寄件者: TsangShun Qi <[REDACTED]>
寄件日期: 2026年08月25日星期二 12:30
收件者: Timothy Wai Pui WU/PLAND
主旨: TKLN 129 response to DSD comment
附件: 752 drainage proposal.pdf; layout plan.pdf; response to dsd comment.pdf
類別: Internet Email

Response to DSD General Comment

Response to DSD Specific Comments

Drainage Proposal

Layout Plan

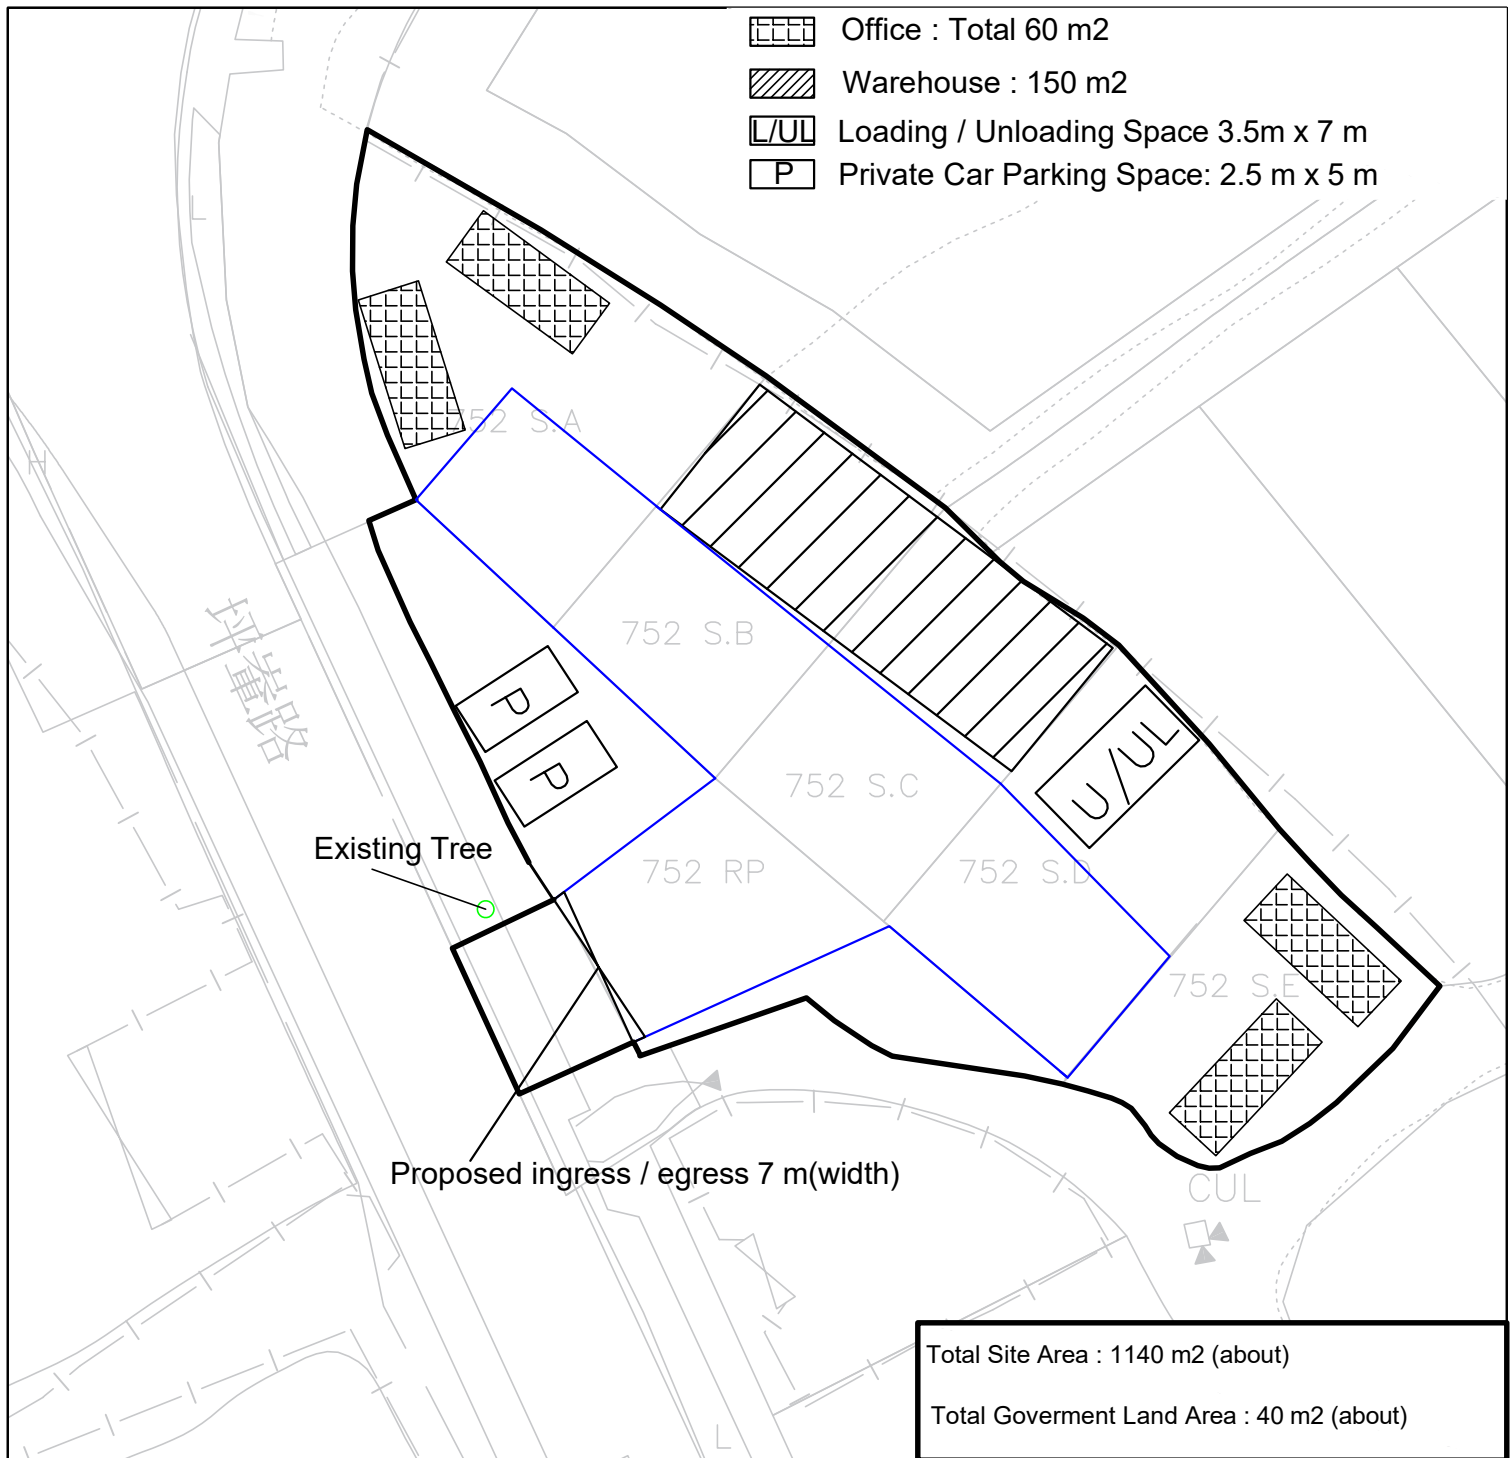
Comment 3
The applicant should supplement photos showing the conditions of the existing u-channel and the streamcourse. A plan should be submitted to indicate the locations of the camera and directions of all photos taken.
Response
Please find revised drainage proposal.

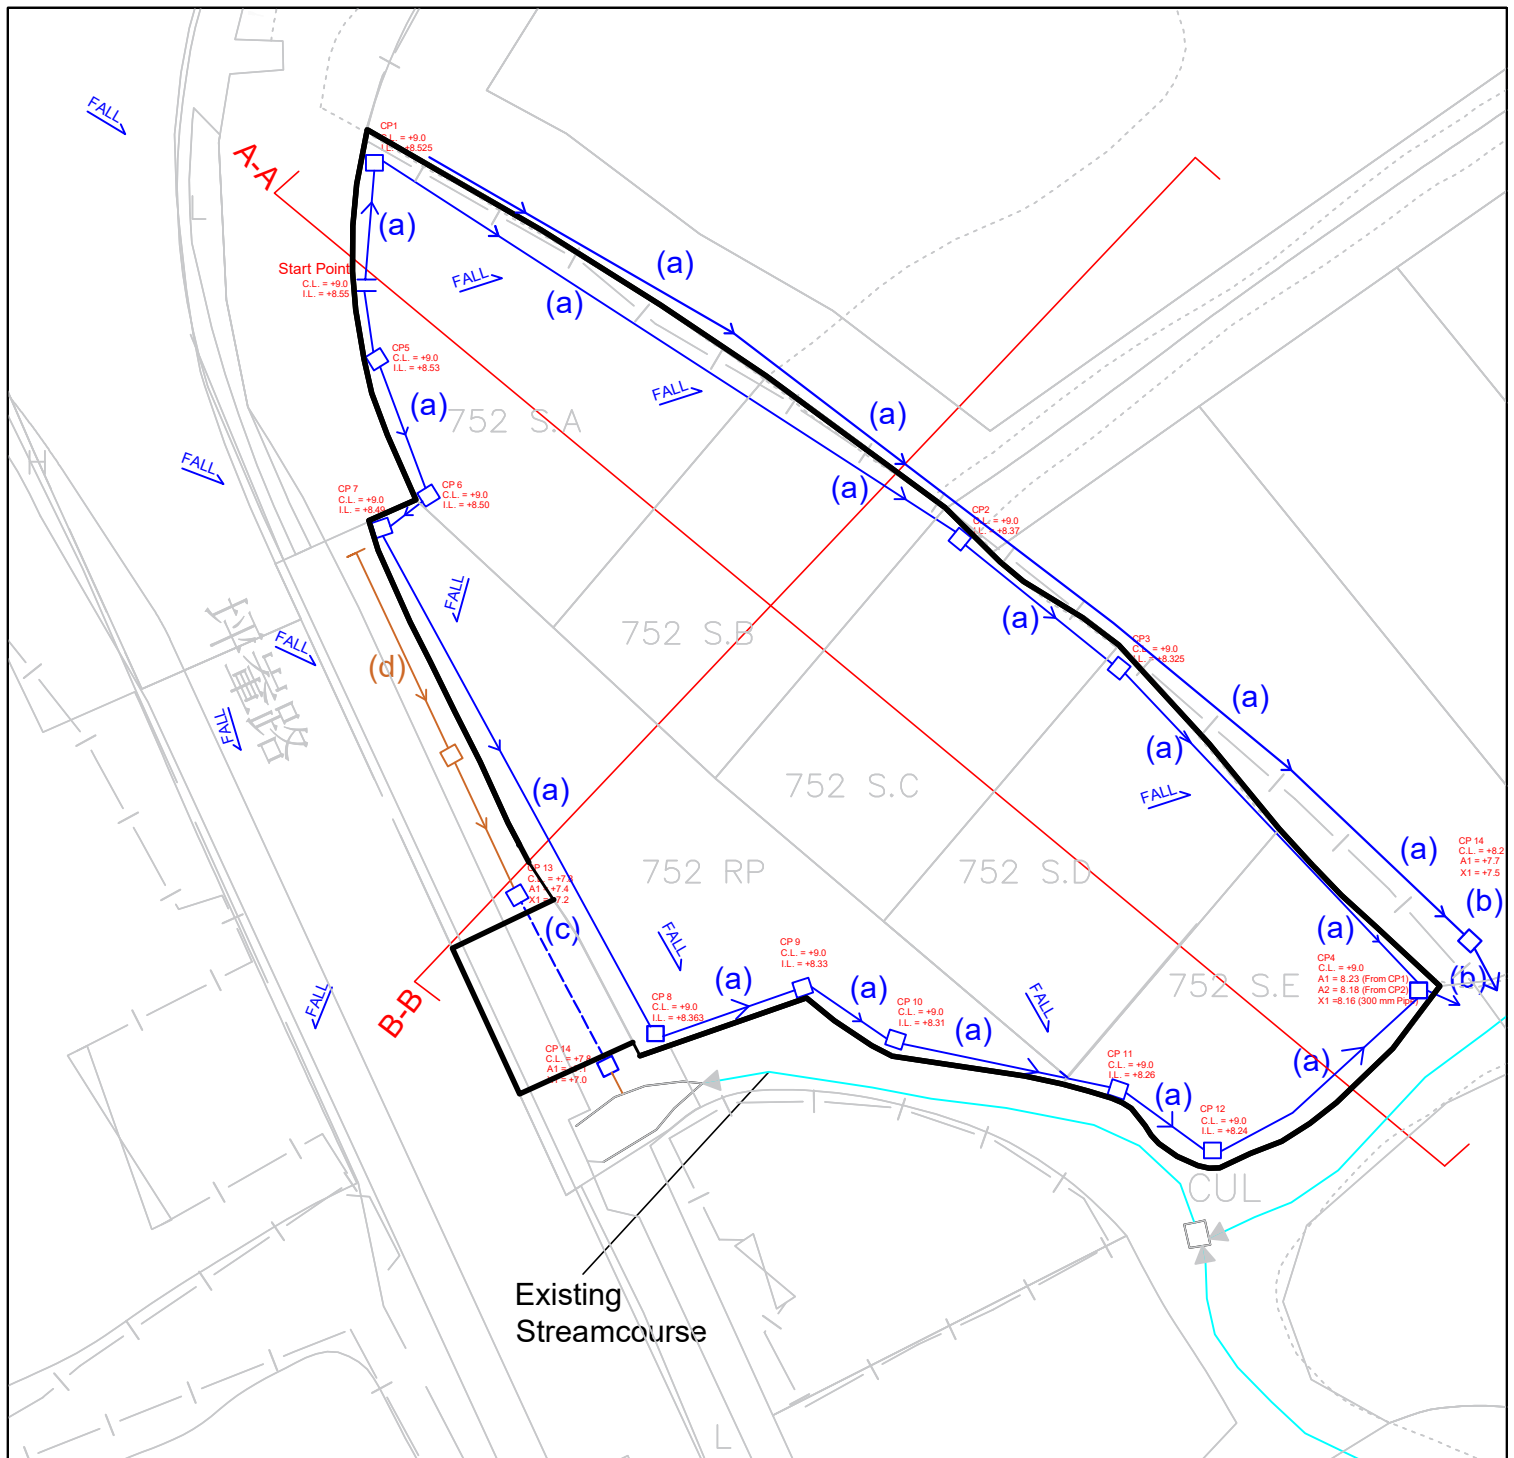
Comment 2
The cover levels of proposed u-channels and catch pits should be flush with the adjoining ground level.
Response
The cover levels of proposed u-channels and catch pits adjusted to the adjoining ground level. Please refer to drainage proposal.

Comment 1
Layout plan refers. a. The applicant should indicate the following on the plan: (i) the location of catch pit to be demolished; (ii) cover and invert levels of the existing/proposed u-channels at the most upstream ends; (iii) cover and invert level of CP13; (iv) gradients of the u-channels and pipes. b. Thickness of concrete cover/grating should be considered when determining the invert levels of catch pits and u-channels to ensure the depths of u-channels are adequate. For instance, the depth of 300UC at CP5 is less than 300mm. c. The applicant should supplement connection details between the proposed 375mm concrete pipe and the existing streamcourse. d. The applicant should consider providing a catch pit at the connection between the proposed 300mm pipe and the existing 300UC. e. The applicant should consider enlarging the proposed 300mm pipe and provide an additional pipe to reduce risk of blockage. f. It is noted that the formation level of the subject site is higher than the adjacent lands. It appears that the existing flow paths of run-off falling onto and passing through the site would be affected. Peripheral channels with proper discharge shall be provided at the toe of the raised platform so as to ensure no adverse drainage impact to lands and premises adjoining the site.

Response
1. The layout plan is revised in proper scale and added the request indication. 2. The Peripheral channels is proposed and indicated on layout plan to ensure no adverse drainage impact to lands and premises adjoining the site. 3. Please find revised drainage proposal.

Figure 8.10 - Typical Details of Catchpits

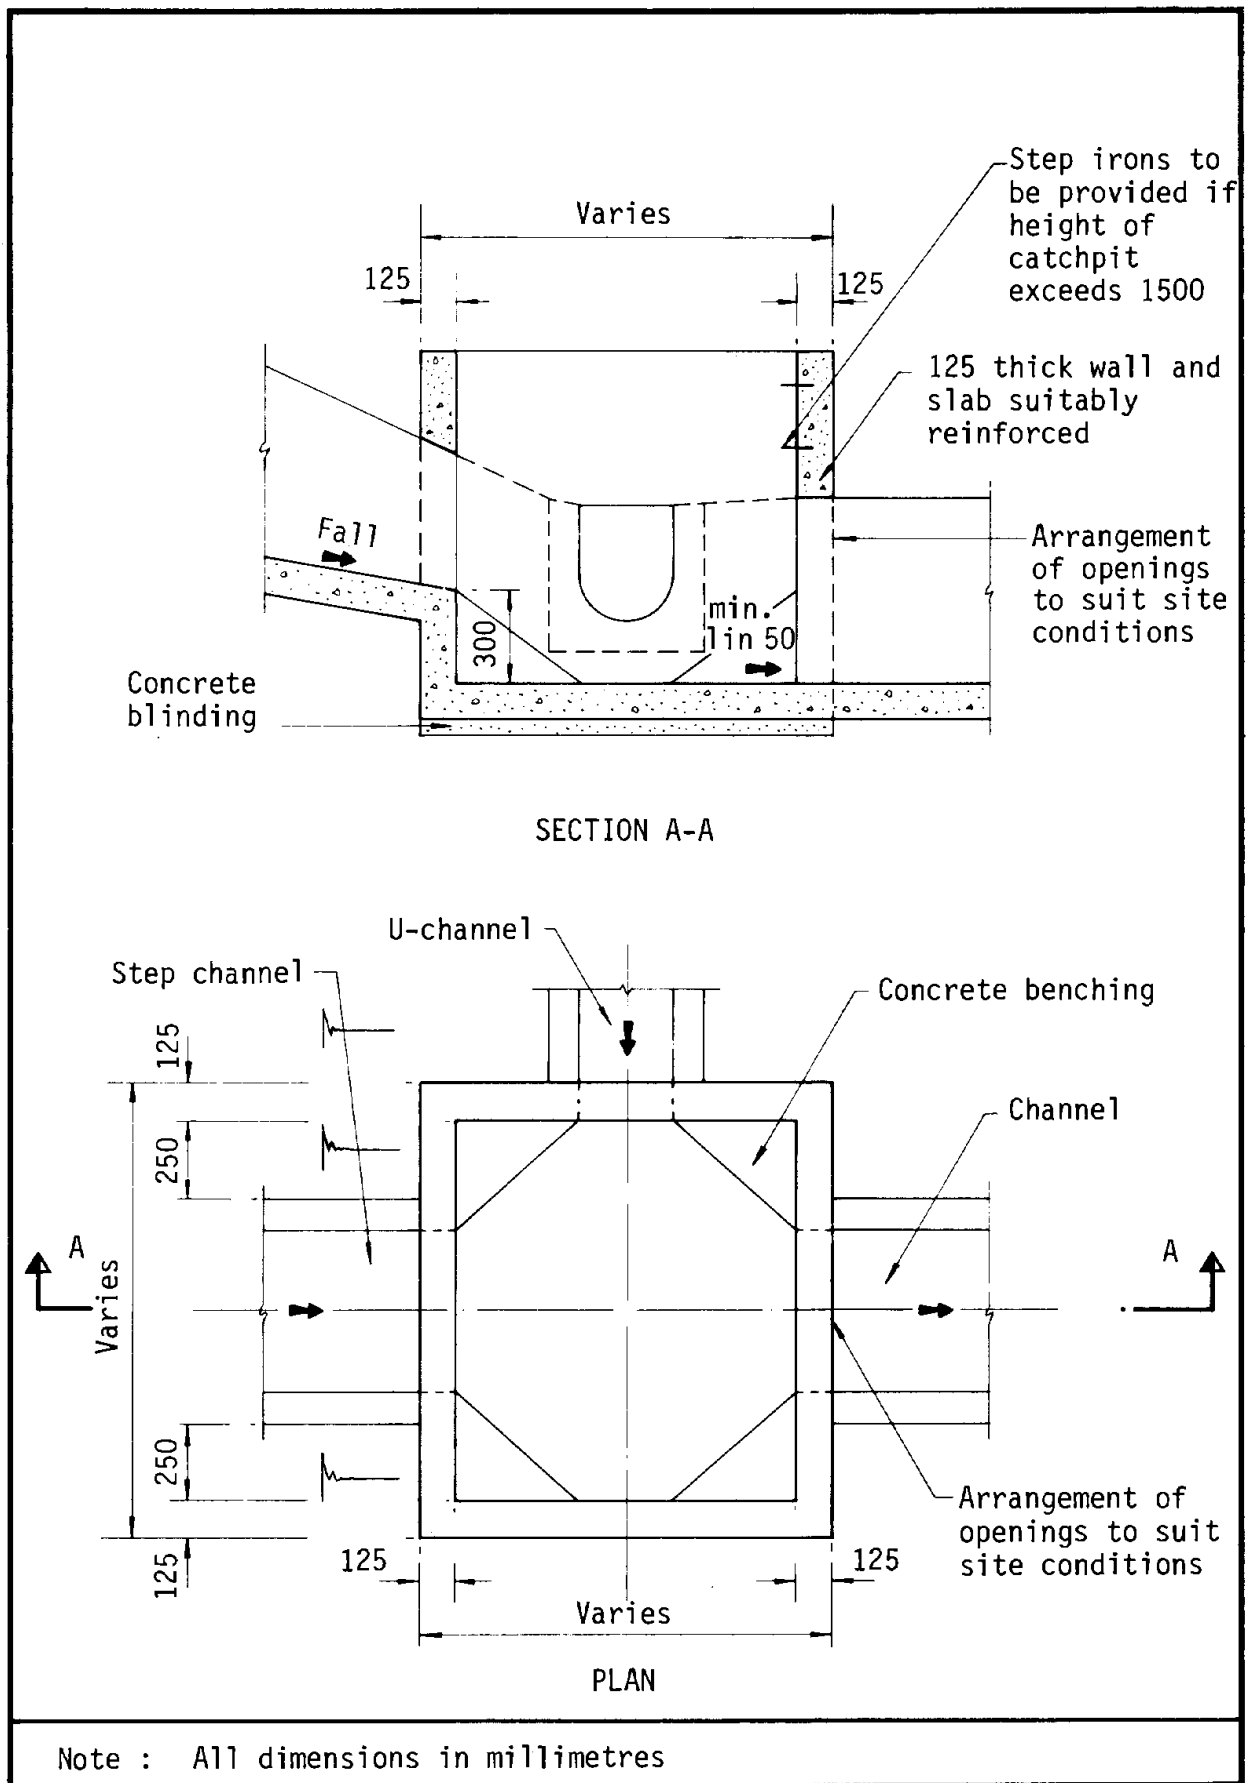
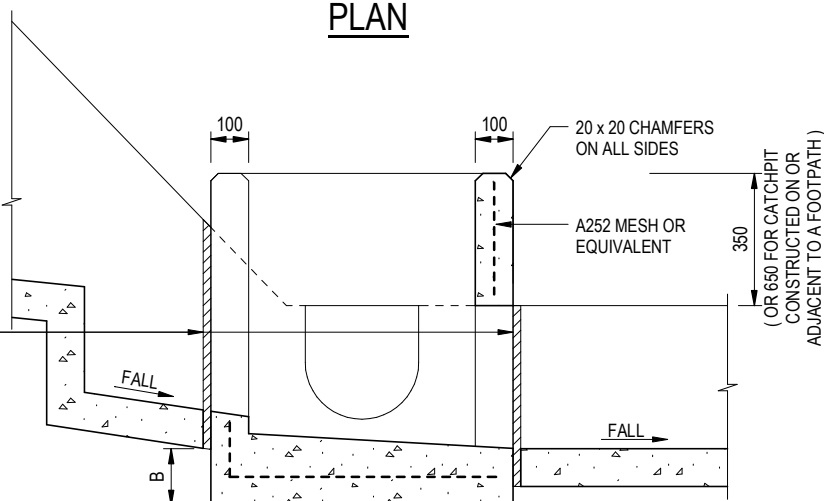
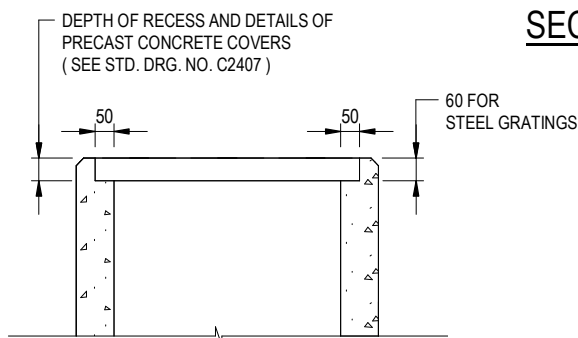
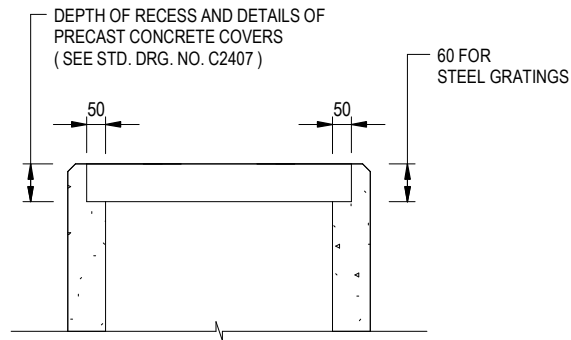
Comment 2
The applicant should supplement design of the proposed 300mm pipe, catch pit with trap, grating for u-channel.
Response
Please find revised drainage proposal.
